Submission to the CIS Assessment Committee on:

- a) The inconsistent traffic forecasts in the CIS which are relied on by the LMA**
- b) The failure to consider prudent and feasible alternatives to the Hoddle St interchange**

*Presented by Andrew Herington on behalf of
Crina Virgona and Nancy O'Toole: Submission 49*

Revised alignment showing low profile ramp for Hoddle St underpass

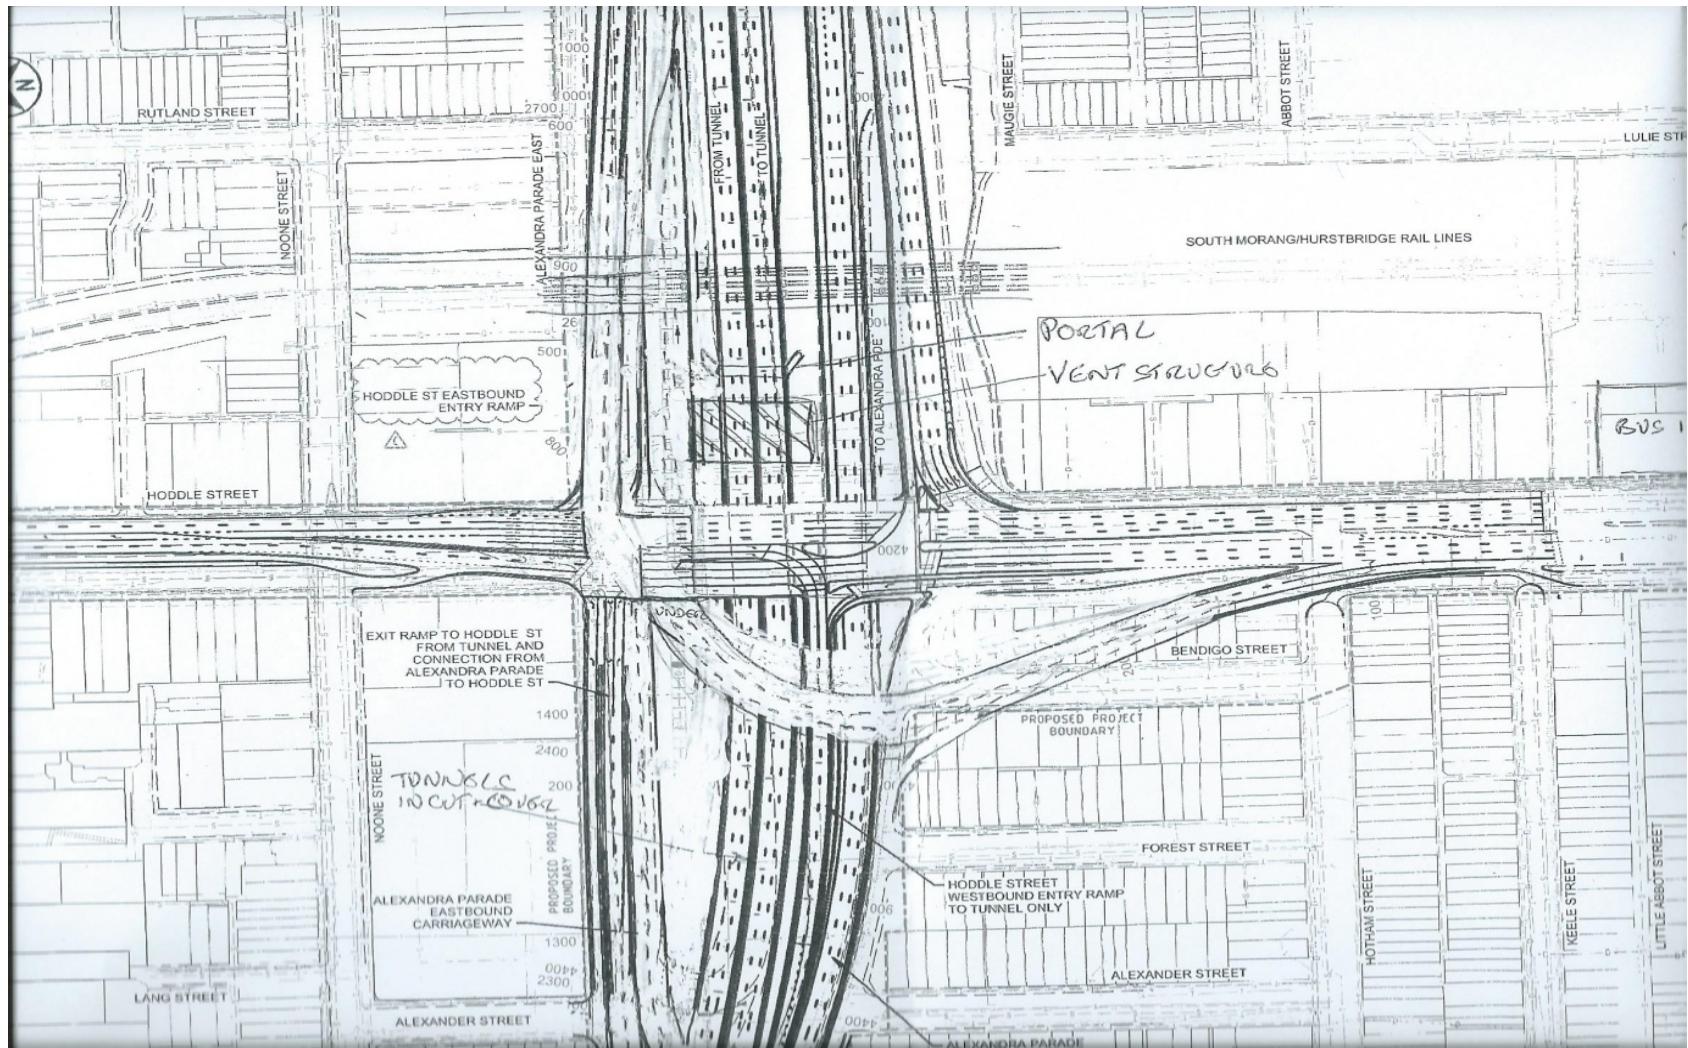
The option of putting the on-ramp below Hoddle St is a feasible and prudent alternative

- The proposed flyover at Hoddle St is an unnecessary, high impact element of the Reference design.
- The LMA has not given proper consideration to alternatives.
- They have used “straw man” arguments to reject the options of P and Q turns and a double diverging diamond intersection.
- Another such option is the following design for a low impact underpass to enable the south to east movement with modest impacts.
- A proposal generally similar to this “Hoddle St Underpass option” has twice been raised by the Counsel Assisting, Mr Chris Wren SC and deserves detailed consideration as a practical and feasible alternative.

- 1. The option of building the on-ramp from Hoddle St to the east as an underpass rather than a high level bridge is a feasible and prudent alternative that has not been adequately considered in the CIS.**
- 2. Traffic is projected to decline from 32,000 vpd to 14,000 vpd making this movement and a lower impact on-ramp is required.**
- 3. A high level bridge has unacceptable visual, dust, noise and air pollution impacts which are avoidable and would be difficult to mitigate.**
- 4. An underpass has significant local benefits and greatly improves visual appearance and other impacts;**
- 5. The Reference design should exclude the proposed flyover and the final selected design should incorporate a P or Q turn with an underpass.**

SIX EXISTING SIMILAR MELBOURNE INTERCHANGES

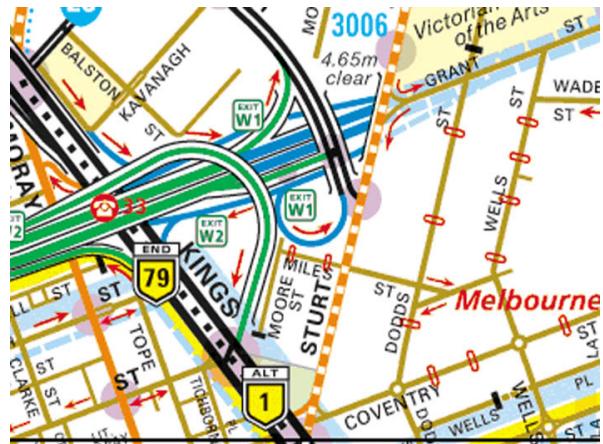
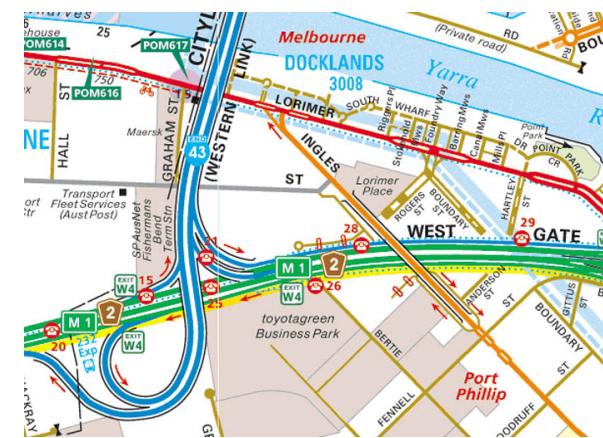
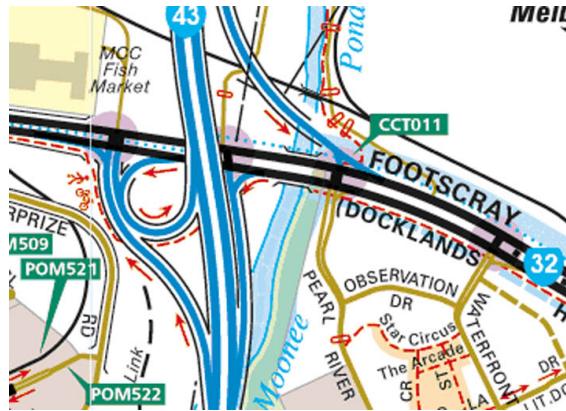
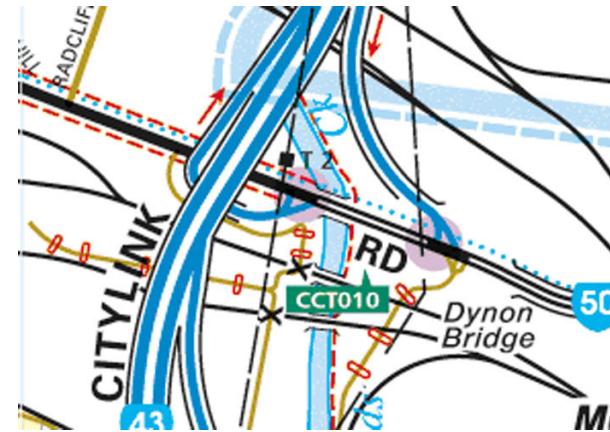
All but one have 60 kph speed limits and less than 50 metre radius curves

- The on-ramp from Dynon Rd is the closest parallel in horizontal geometry
- The speed on the Hoddle St on-ramp would be 60 kph;
- There might be some queuing with ramp monitoring;
- The DART bus could have a jump lane rather than a full length bus lane
- Tight geometry is less of a problem for on-ramps (compared to freeway to freeway interchanges).
